SERVICE BULLETIN

M-889

1984 MODEL FXST SHOCK ABSORBER BOLTS

Figure 1. Torque Wrench with Adaptor

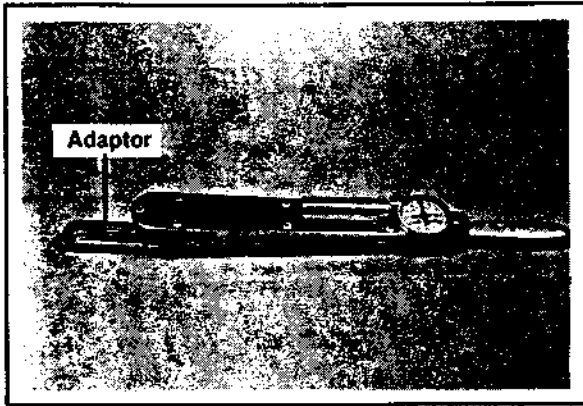
FXST shock absorber bolt torquing procedure requires the use of a SNAP-ON ADAPTOR, Part No. SRES 24, to allow accurate torquing. See Figure 1.

Bolt torque must be computed because the adaptor effectively lengthens the torque wrench. A TORQUE COMPUTER is available from Snap-on, Part No. SS-306D, for use when an adaptor or extension is added to any torque wrench. The computer can easily be used with dial or click type torque wrenches.
